SERVICE BULLETIN

NUMBER 004 (REVISED)

MODEL 89 AE, EL, SV/VV,
ST, YR, RN, VN, FJ

AUTO REVERSE CASSETTE (P/N 08690-00810) MODEL 5906 INSTALLATION

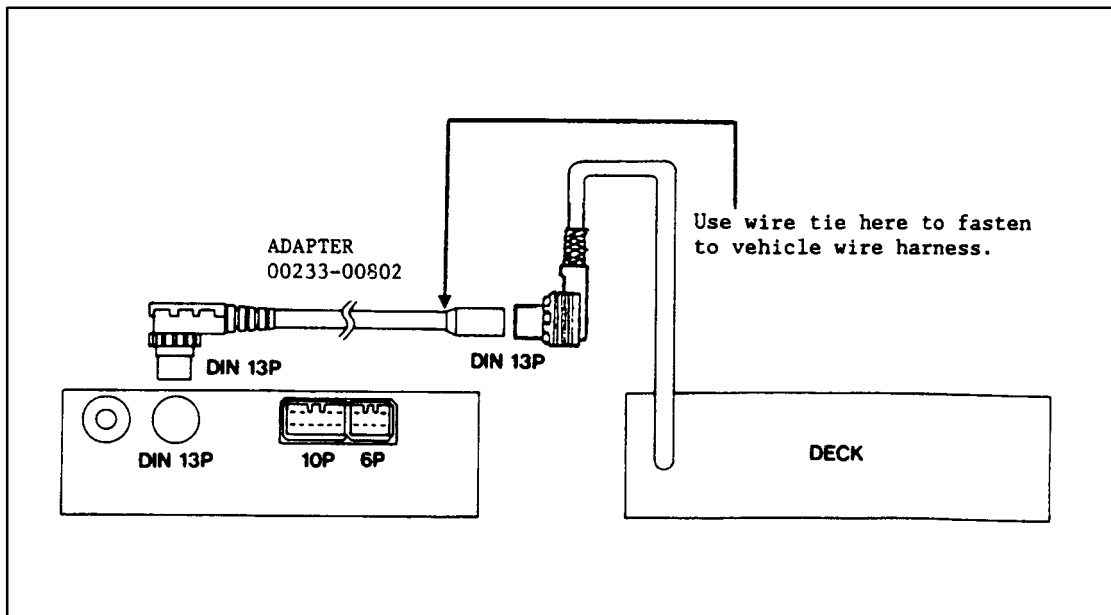
An adapter cable (P/N 00233-00802) is now required to ensure proper locking of the DIN connector.

Once connections have been made, use a plastic tie strap or electrical tape to fasten the 13 pin DIN connector adapter cable to the vehicle wire harness (see figure on page 2).

- 1) Verify that the applicable radio and cassette deck units are installed (ie., model 1432, A1432, 1433, or A1433 AM/FM ETR with model 5906 Cassette Deck).
- 2) Install adapter cable P/N 00233-00802 as shown on the figure below.
